# **Groundwater Transfer Review Summary Form**

### Transfer/PA # T- <u>14528 RA</u>\_

GW Reviewer <u>Stacey Garrison/Travis Brown</u> Date Review Completed: <u>10/24/2024</u>

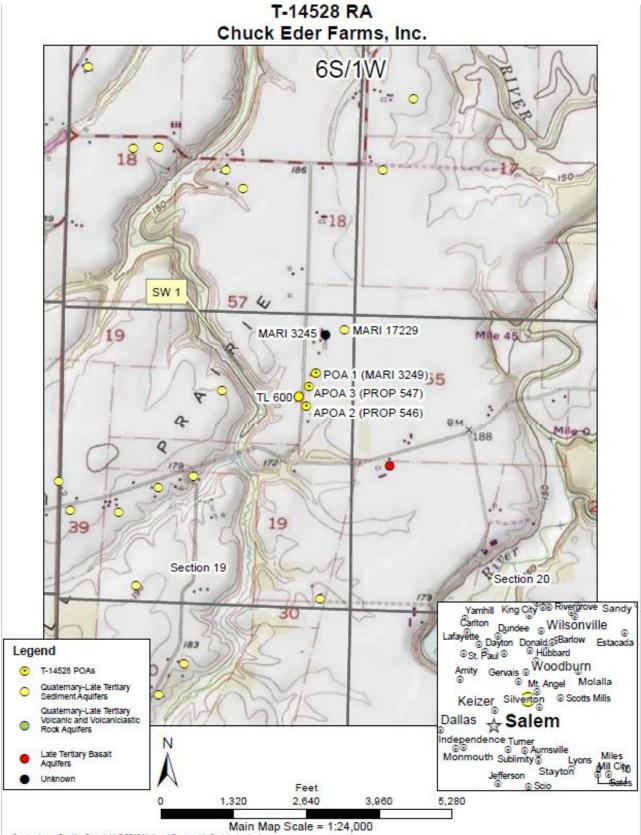
Yes D No Comments: <u>The APOAs 2 (**PROP 546**</u>) and 3 (**PROP 547**) are closer to neighboring tax lot 600, which is presumed to be served by exempt domestic wells ("Tax Lot 600 Well"). The closer proximity of this domestic well will increase interference.

a) Will this proposed change, at its maximum allowed rate of use, likely result in an increase in interference with another surface water source?
☑ Yes □ No Comments: <u>The APOAs 2 (PROP 546) and 3 (PROP 547) are closer to Howell Prairie Creek than the authorized POA (MARI 3249). The closer proximity to the creek will increase interference.</u>

Provide context for minimal/significant impact: <u>Although somewhat closer to Howell Prairie</u> <u>Creek, the percentage increase in interference from APOAs 2 (**PROP 546**) and 3 (**PROP 547**) should be minimal due to the ~100 ft thick layer of fine-grained sediment (Gannett and Caldwell, 1998) underlying the creek which will diffuse depletion from groundwater pumping over a broad area and span of time.</u>

## **Theis Drawdown**

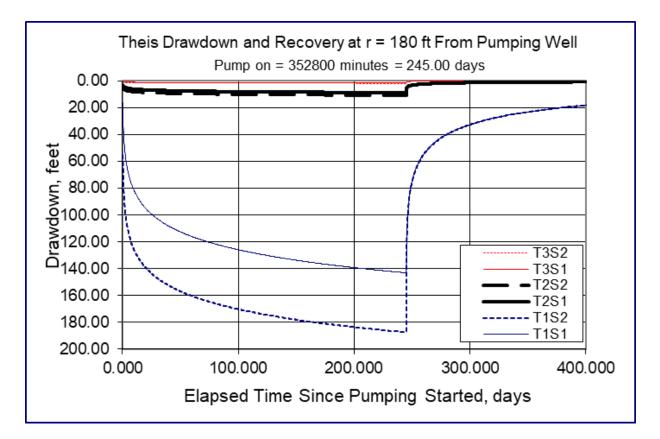
b) If yes, would this proposed change, at its maximum allowed rate of use, likely result in another groundwater right not receiving the water to which it is legally entitled? □ Yes ⊠ No If yes, explain: <u>APOA 2 (**PROP 546**) is 180 ft SE of the</u> presumed location of the Tax Lot 600 Well. The Theis (1935) solution was used to assess interference from proposed APOA 2 (**PROP 546**) at the presumed location of the Tax Lot 600 Well (see attached Theis Interference Analysis). Results indicate that the proposed change is unlikely to injure the Tax Lot 600 Well. APOA 3 (**PROP 547**) is further from the presumed location of Tax Lot 600 Well, and would result in even less drawdown and is therefore unlikely to injure the Tax Lot 600 Well.

Total pumping time, t = 245 days [irrigation season, March 1-October 31]

**Radial distance, r = 180 ft** [approximate distance from APOA 2 (**PROP 546**) to presumed location of Tax Lot 600 Well]

Pumping rate, Q=0.28 cfs [maximum rate, Certificate 39904]

Transmissivity: T1=100 ft<sup>2</sup>/day; T2=2,300 ft<sup>2</sup>/day; T3=15,600 ft<sup>2</sup>/day [Pumping Test Reports]

Storativity: S1=0.0001; S2=0.001 [Conlon et al., 2005]
